Paradise Ranch  
Land Owners Association, Inc  
P. O. Box 2426  
Victoria, TX 77902

December 13, 2008

Re: Exelon's Victoria County, Texas Application

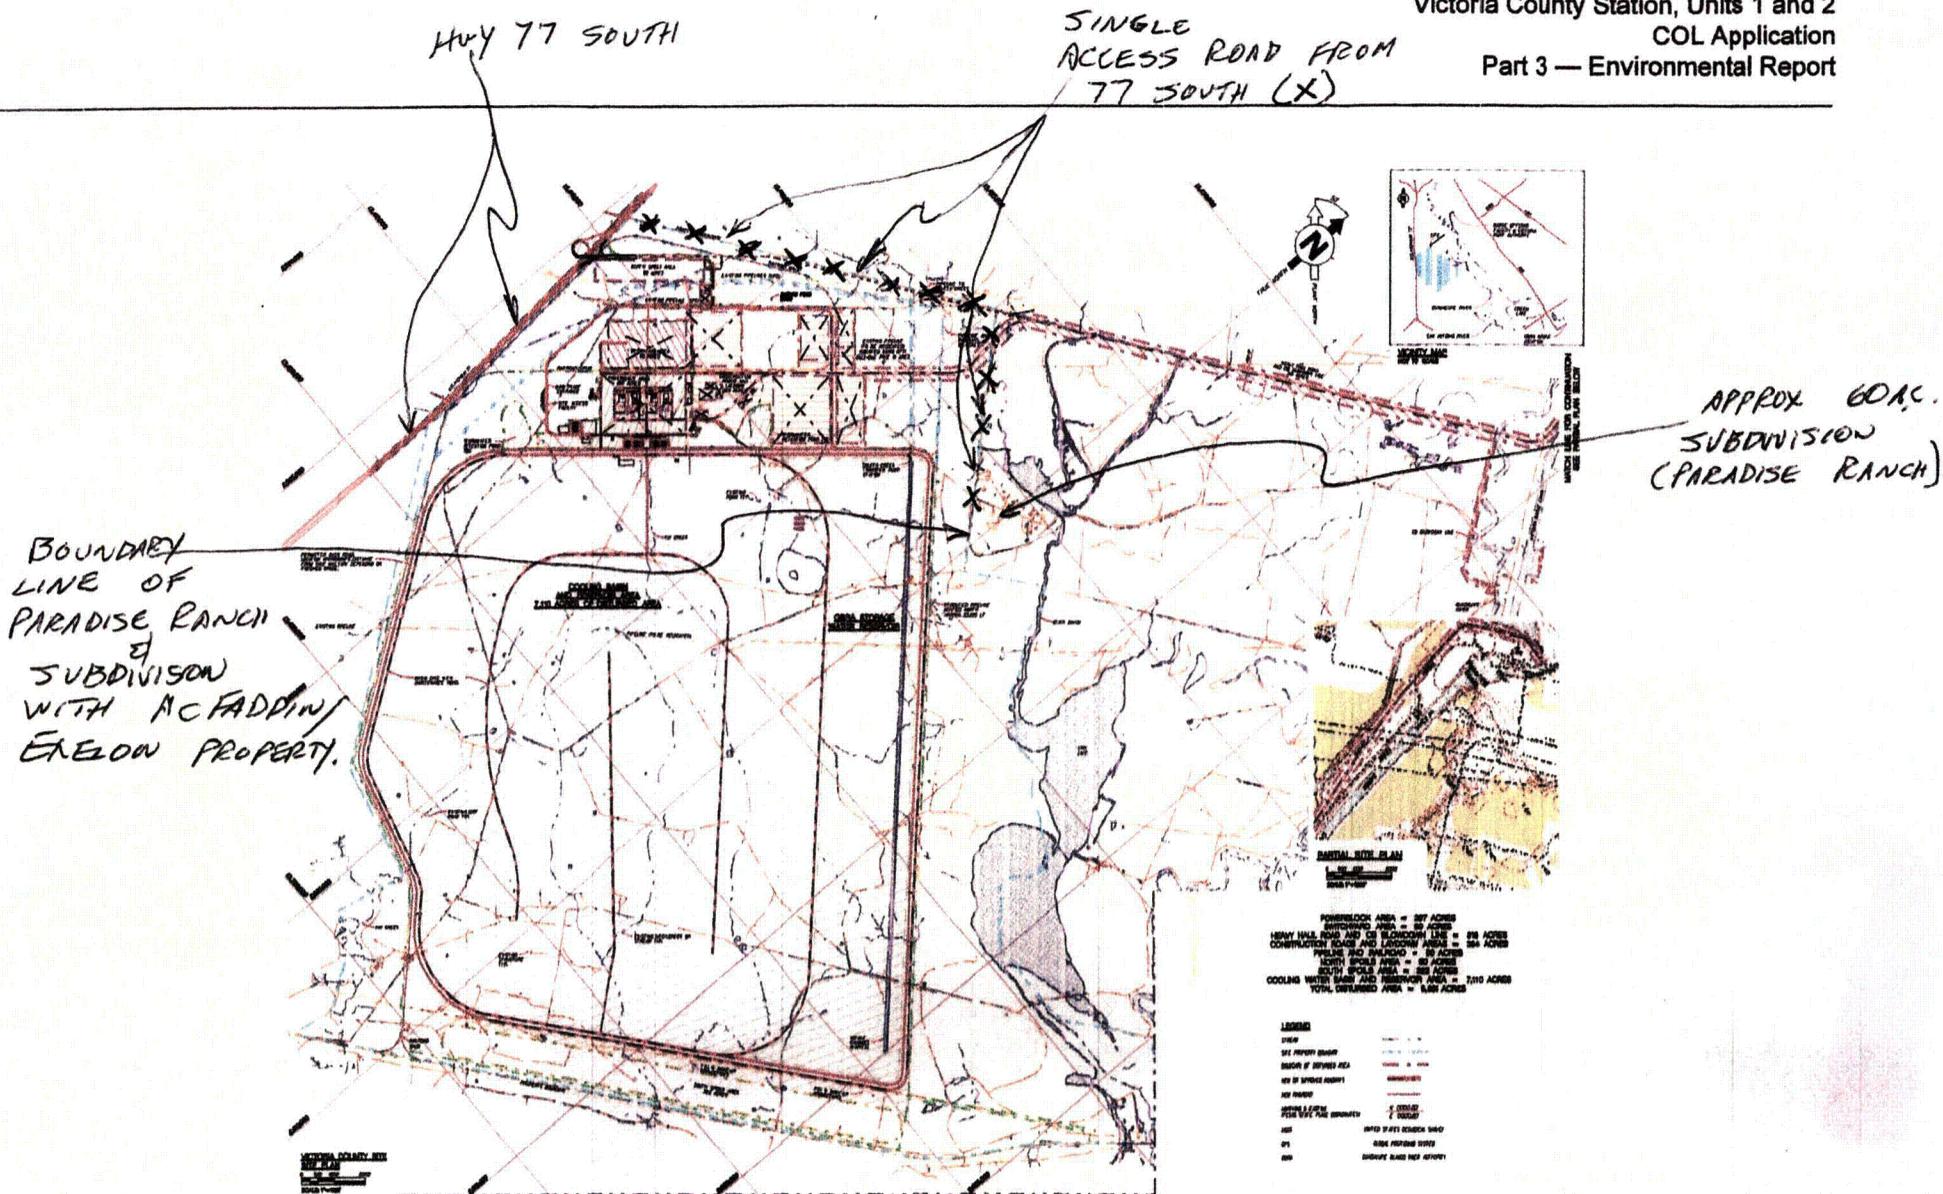
Exelon has also identified our property to have the majority of the Heavy Haul Road located across it. The proposed roadway is directly across our existing ingress and egress easement road from Hwy 77 South. In addition to our Ranch there are two other ranches known as the Gibbs and Stubblefeild ranches that also use the easement road. Exelon did

not address anything about our access in their application. We were told by Exelon representatives at our homeowners meeting that we would not be allowed to use the Heavy haul road for approximately 10 years. On any given day there are 25 to upwards of 200 people on the three ranches. We have included a map from Chapter 3 of the permit application with our notations so that you may better understand our positions and concerns.
